CERTIFICATE OF APPROPRIATENESS

Property: 8106 Glencrest Street, lot 2, block 2, Section 1 Glenbrook Valley Subdivision. The property includes a historic 2,308 square foot residence situated on a 12,600 square foot interior lot.

Significance: Contributing Traditional Ranch style residence, constructed circa 1955, located in the Glenbrook Valley Historic District.

Proposal: Alteration – Windows

BAY WINDOW DETAIL

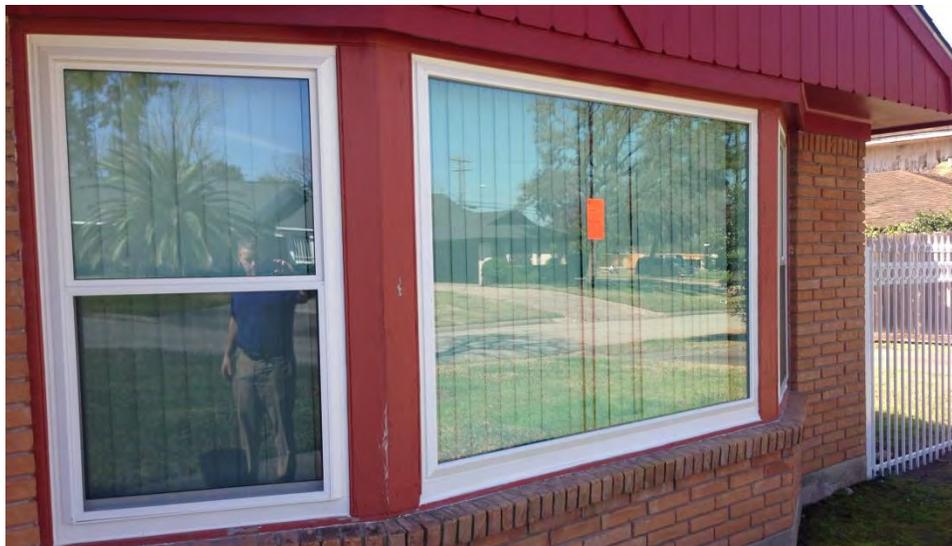
- (1) The proposed activity must retain and preserve the historical character of the property;
The residence's front elevation fenestration of 8 individual windows, including a bay window, is a character defining feature of this property. Removing two pairs of these windows for single lite casement windows adversely alters the fenestration of the façade.

- (5) The proposed activity must maintain or replicate distinctive stylistic exterior features or examples of skilled craftsmanship that characterize the building, structure, object or site;
The replacement of two pairs of 6-over-6 windows with single light picture windows represents a failure to maintain or replicate the distinct fenestration of the existing Contributing residence. This is especially true on the bay window on the north side of the front elevation where the window frame was permanently altered in order to accommodate the larger window.

8106 Glencrest: The replacement of 2 over 2 aluminum frame windows with 1 over 1 or large glass pane, wide vinyl frame windows is not acceptable. Additionally, the applicant has modified the structure/window dimensions of windows designated A/B and F/G.

Recommendation: **Approval with Conditions: Replace the two picture windows with four 1-over-1 windows and restore the vertical trim removed from the bay window.**

HAHC Action: **Approved with Conditions: Replace the two picture windows with four 1-over-1 windows and restore the vertical trim removed from the bay window.**
